ADDENDUM #4
SCCOE RIDDER PARK BACKUP GENERATOR

Bid # B 03-23-24

SANTA CLARA COUNTY OFFICE OF EDUCATION

Prepared by Architect
Artik Art and Architecture
394-A Umbarger Road
San Jose, CA 95127
(408) 224-9890

File No.	Drawing No.
Application No.	A2.11
Date	
Project Number

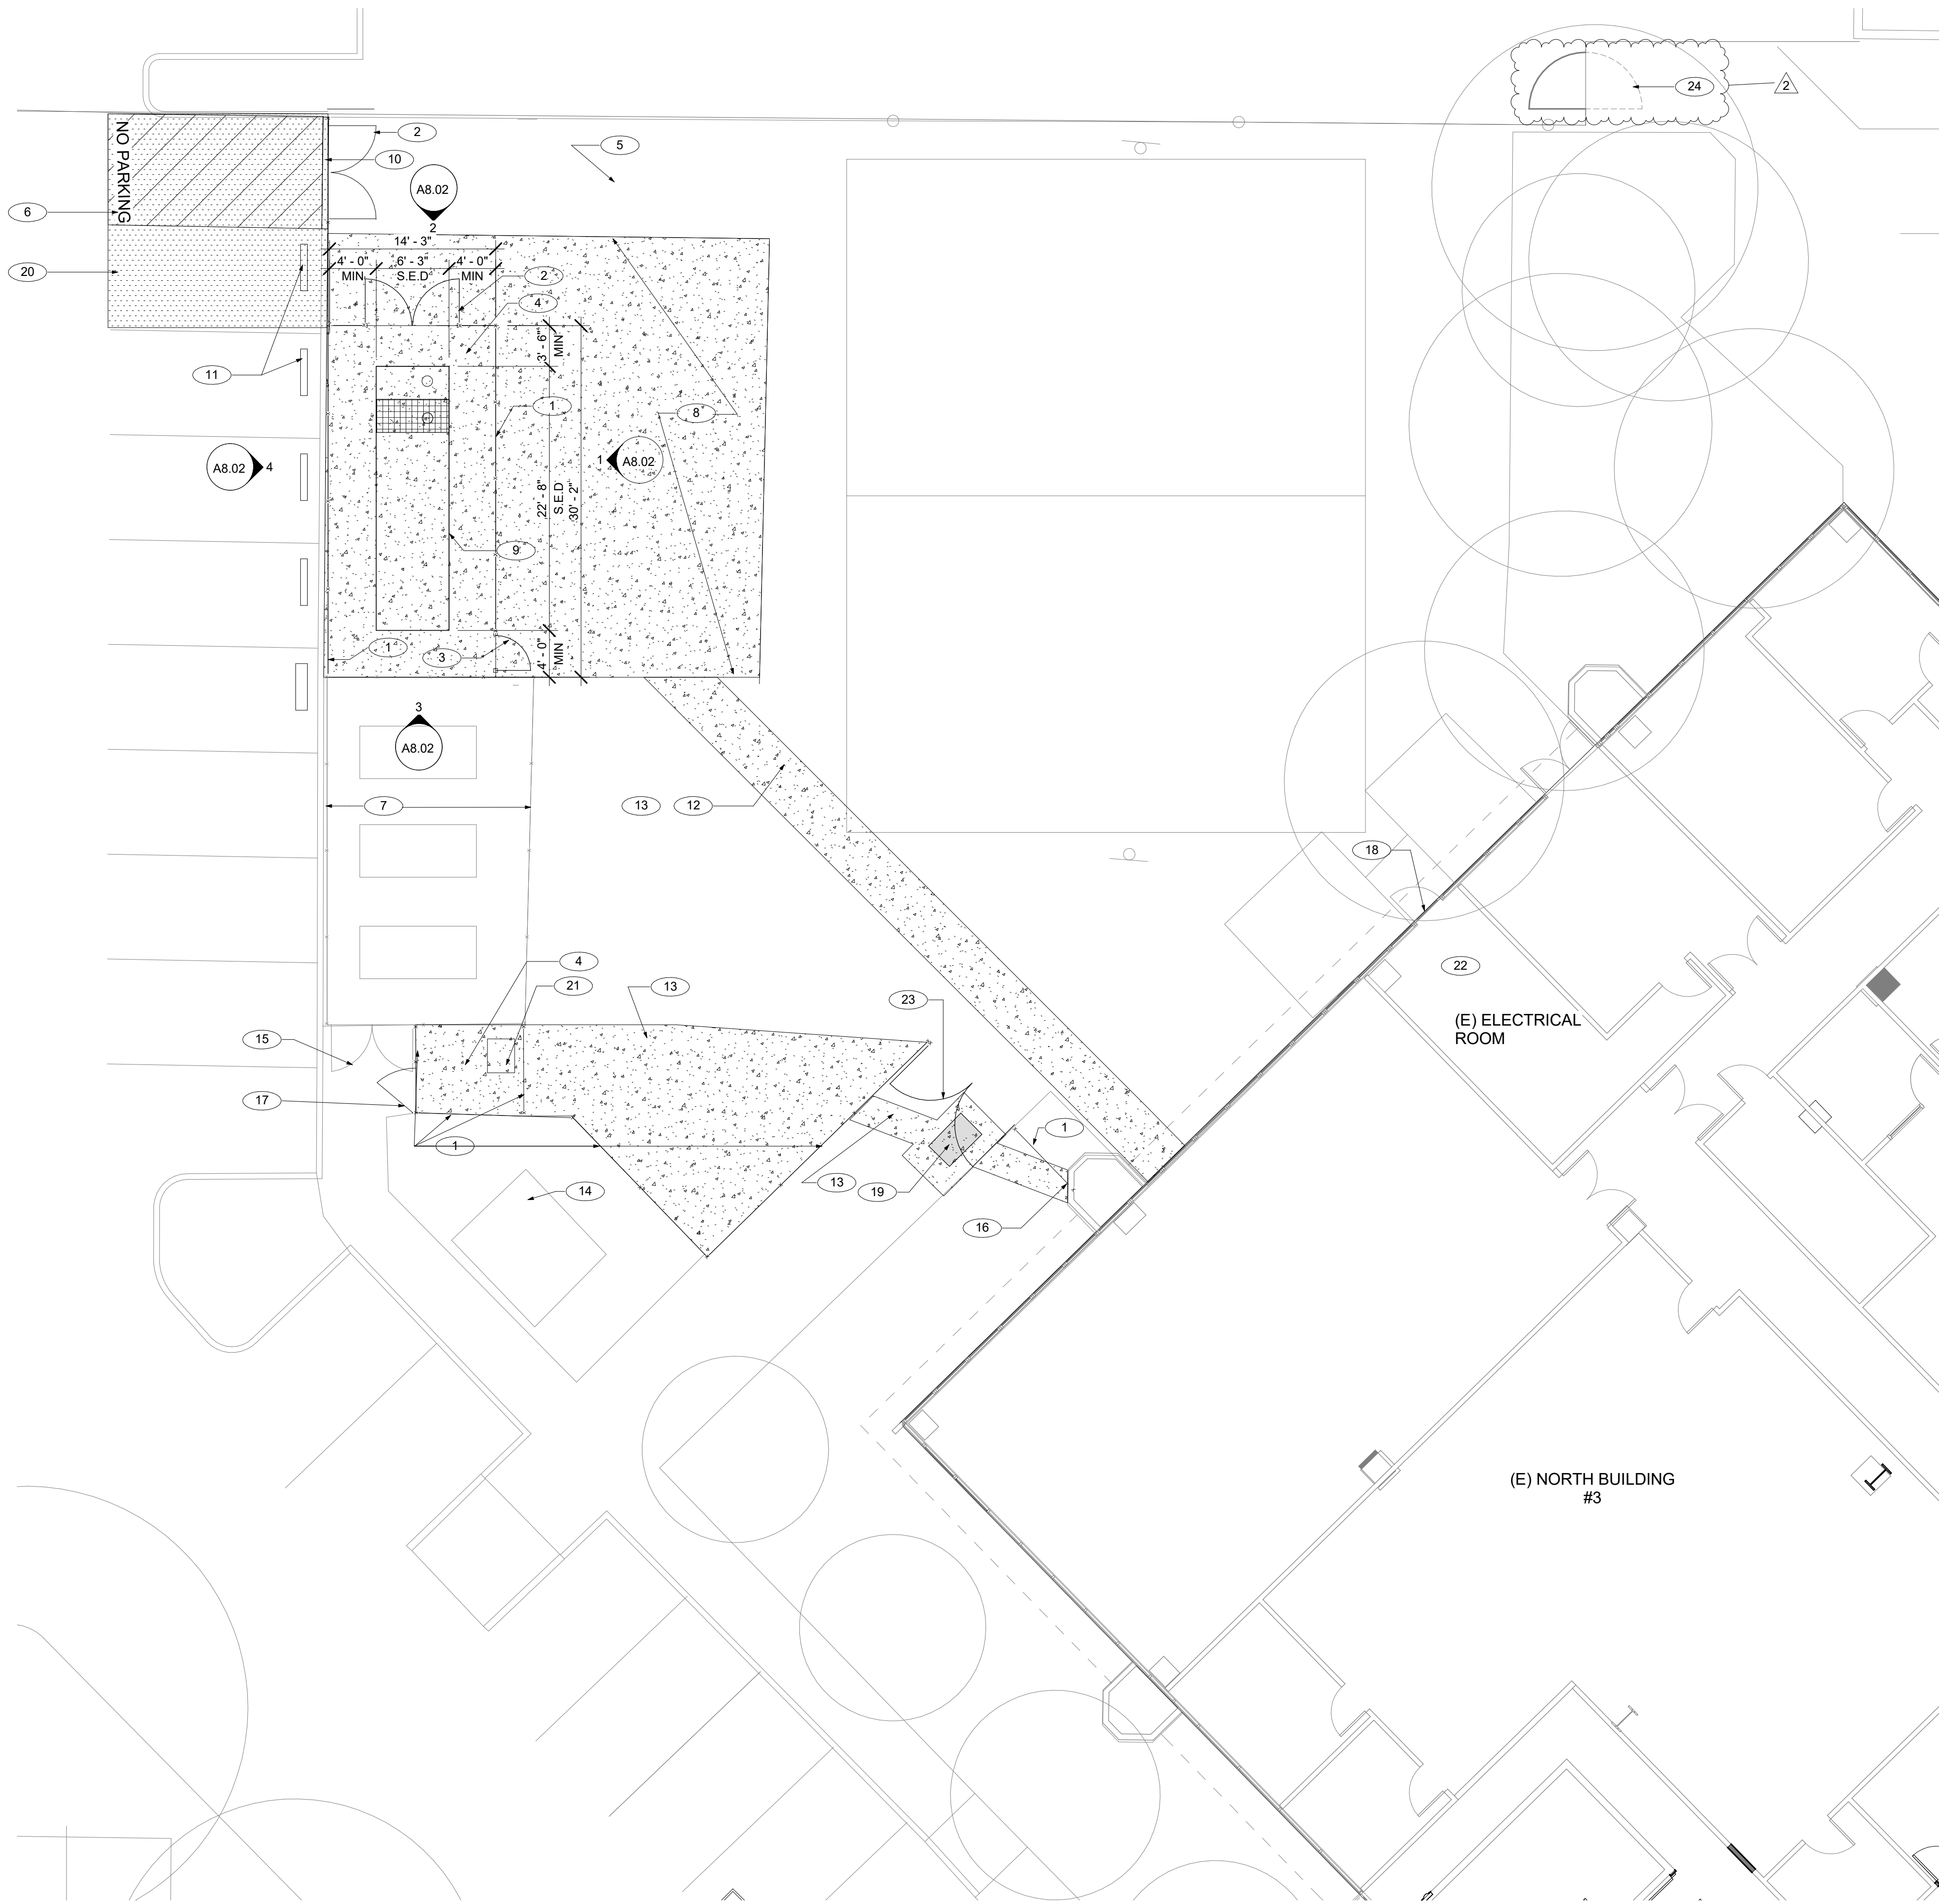
Item 1. Sheet A2.11:

A. Keynote 24- added for (e) gate reverse swing and new hardware

19 GATE POST DETAIL 3" = 1'-0"

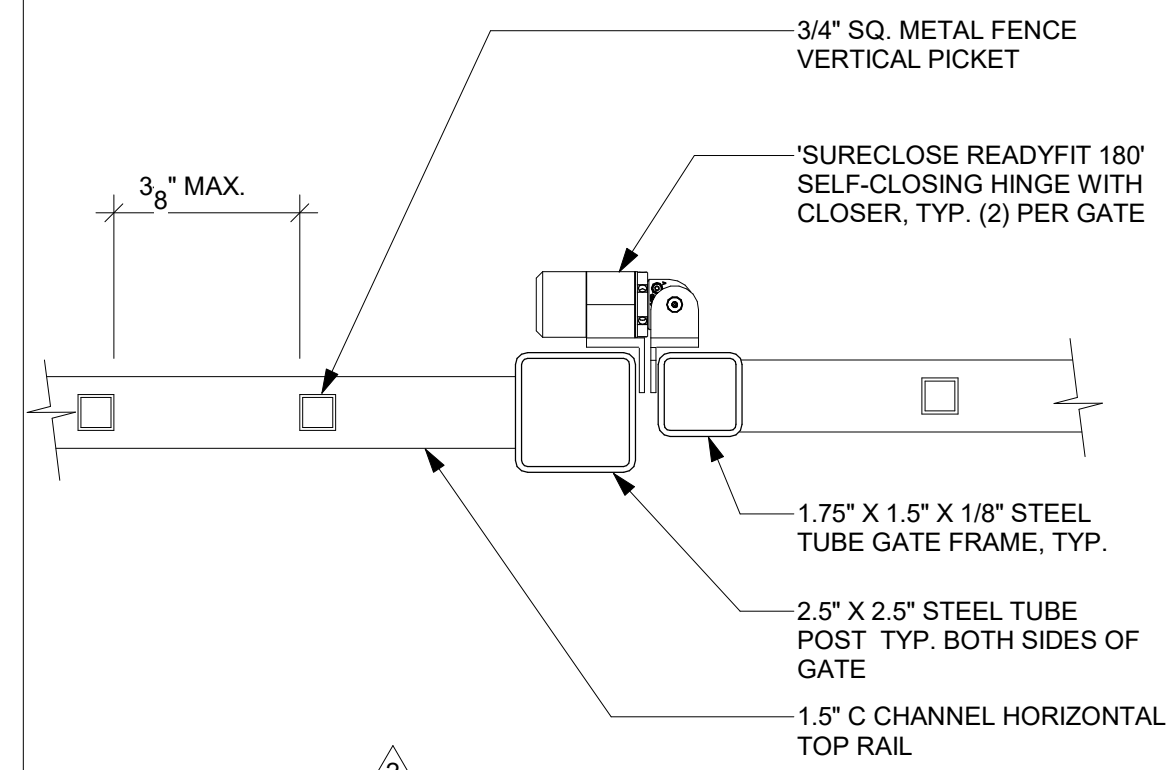
d. Added Detail 19 for hinge @ ornamental gate

3 ORNAMENTAL SINGLE SERVICE GATE 1/4" = 1'-0"

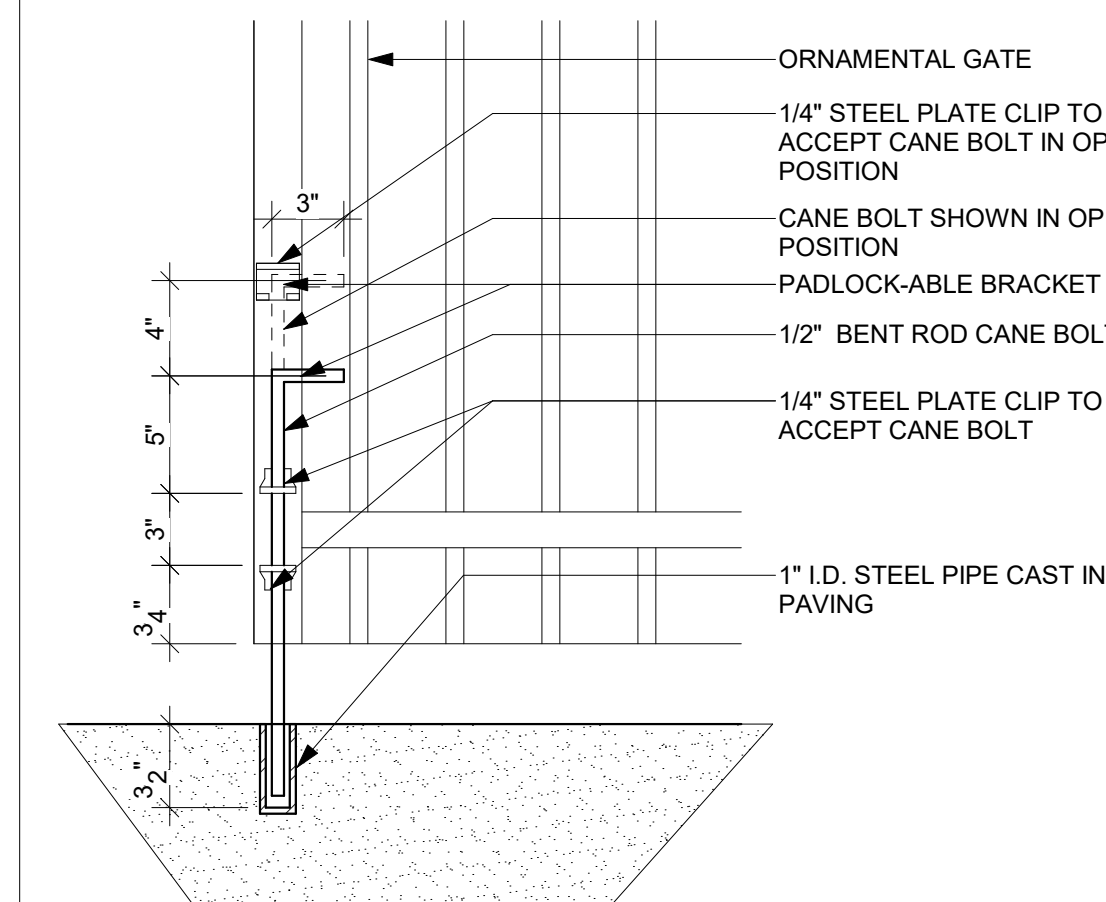
A. Detail 3 - refer to updated notes

3. Please provide the lever lockset model etc... for the single gate 3/A12.11.

Answer: Lever lockset with cylinder interchangeable core, refer to updated details

16 CHAIN LINK FENCE 1/4" = 1'-0"

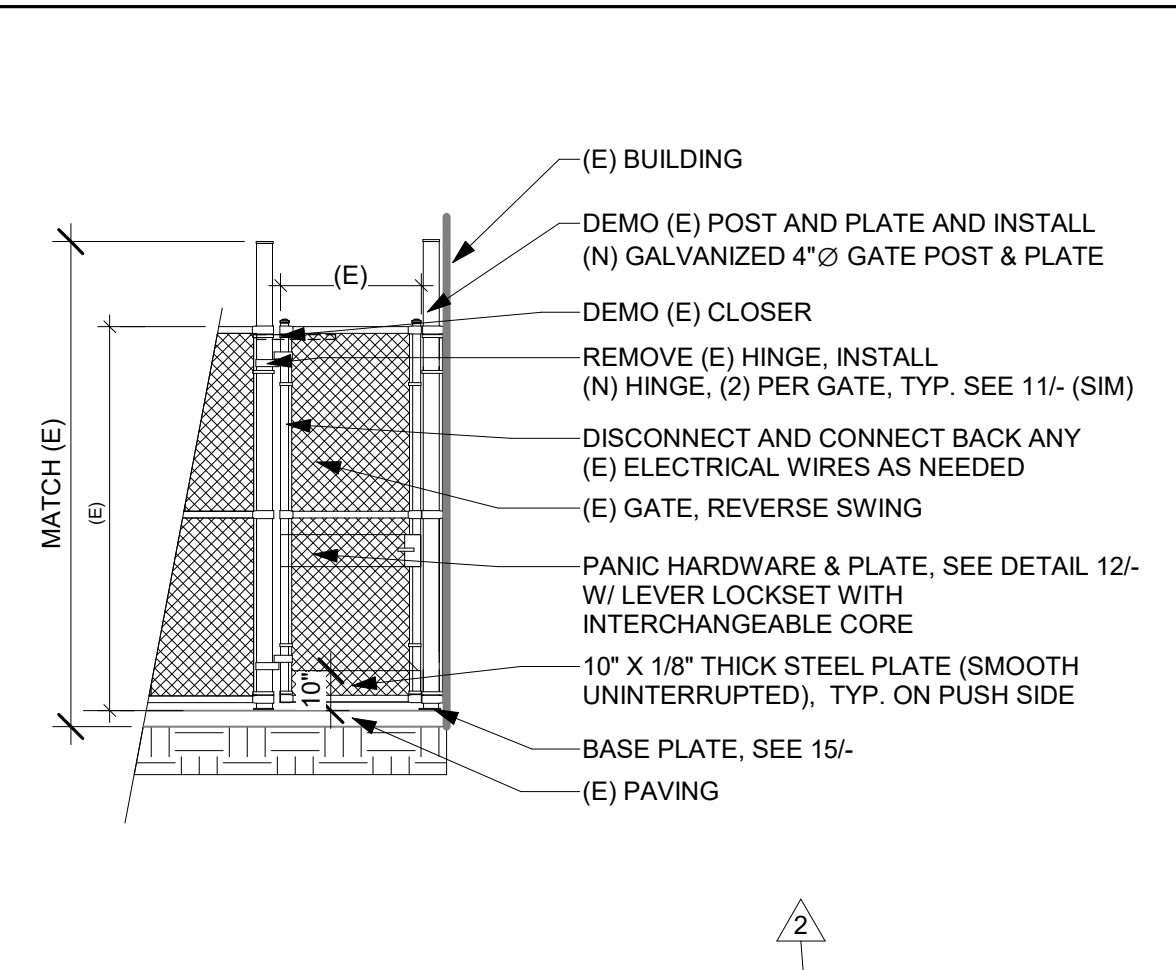
- A. Detail 4 – refer to updated notes
- B. Detail 5 – refer to updated notes
- C. Detail 6 – refer to updated notes
- D. Detail 9 – refer to updated notes
- E. Added Detail 11 for self-closing hinge
- F. Added Detail 15 for the base plate
- G. Added Detail 16 for existing gate modifications

11 HINGE AT CHAIN LINK GATE 3" = 1'-0"

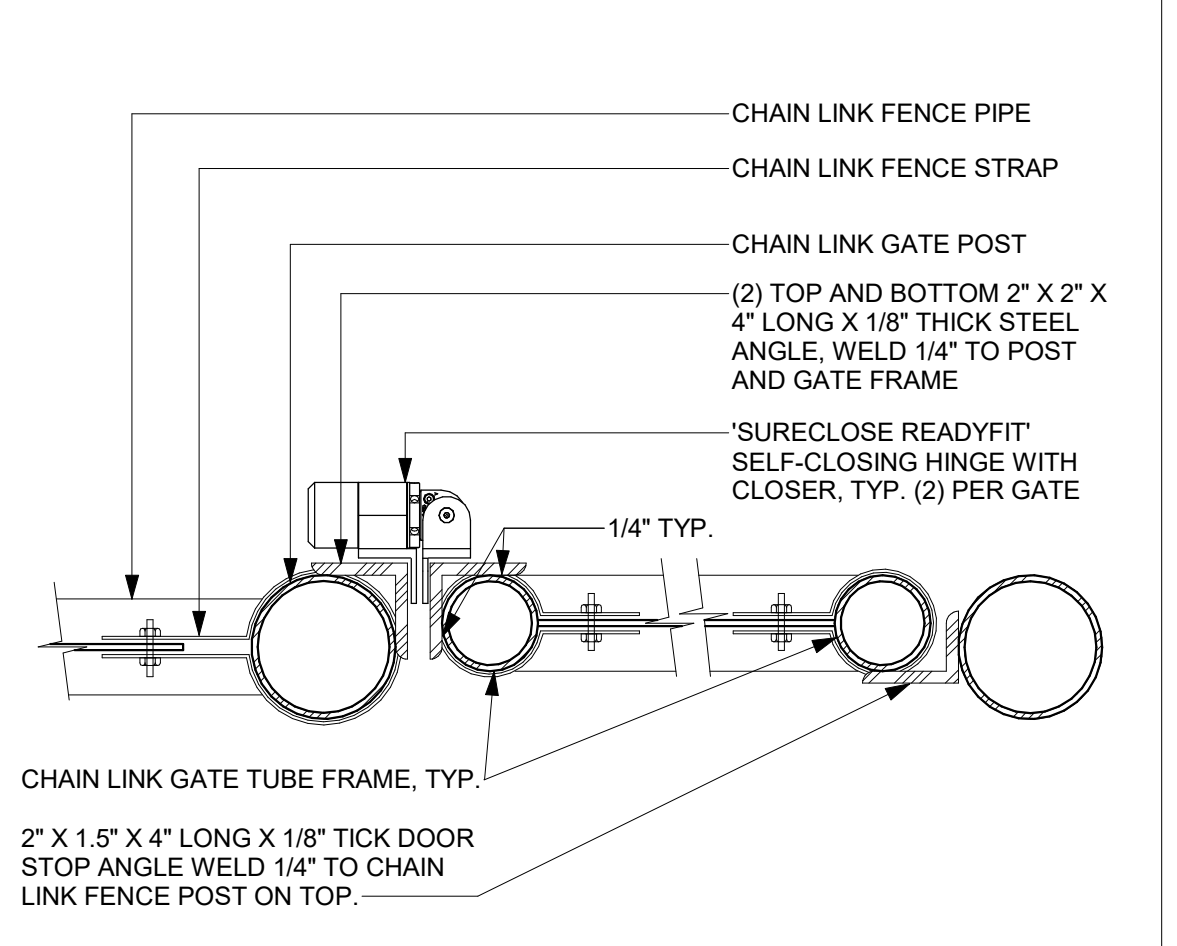
10. Detail 9/A12.12 are self-closing hinges required at this gate since the gates have panic hardware?

Answer: Refer to updated detail for self – closing hinges, 11/A12.12
